Public Meeting Summary

Individual Environmental Report Supplemental 14 – Harvey to Westwego Levee Thursday, Feb. 4, 2010

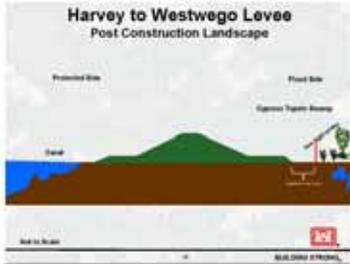
Question 4. Dr. Barry Kohl: On the description of the levee. The cross section went from 150 to 325 ft. Are you going to have to clear vegetation in front of the tow of the levee? How much additional land do you want to clear?

Question 5. Dr. Barry Kohl: So where the tow stops, there will be another 15 ft of clearance needed?

Question 6. Dr. Barry Kohl: that's within the 250 ft?

Question 16. Dr. Barry Kohl: In reading the new standards, it relates to foundations to prevent water seeping through under the levee. Because this segment was made to 350 ft, what did you find under the levee to cause you to make that [determination]?

Response 4. Julie Vignes: Yes, we will clear on the flood side of the existing tow to make the wider levee. The clearing will be within that 350 ft. It includes the new levee and the berm and the vegetative free zone.

Response 5. Julie Vignes: Yes, that includes the levee construction and beyond tow a 15 ft vegetative free area.

Response 6. Julie Vignes: It's all within the 350 ft.

Response 17. Richard Pinner: The big thing that controlled the footprint is the stability analysis and our factor of safety. This levee is being raised, we're raising it 14 ft. We require a larger berm. It's for stability for the protected side and the flood side. The footprint can handle both those conditions.
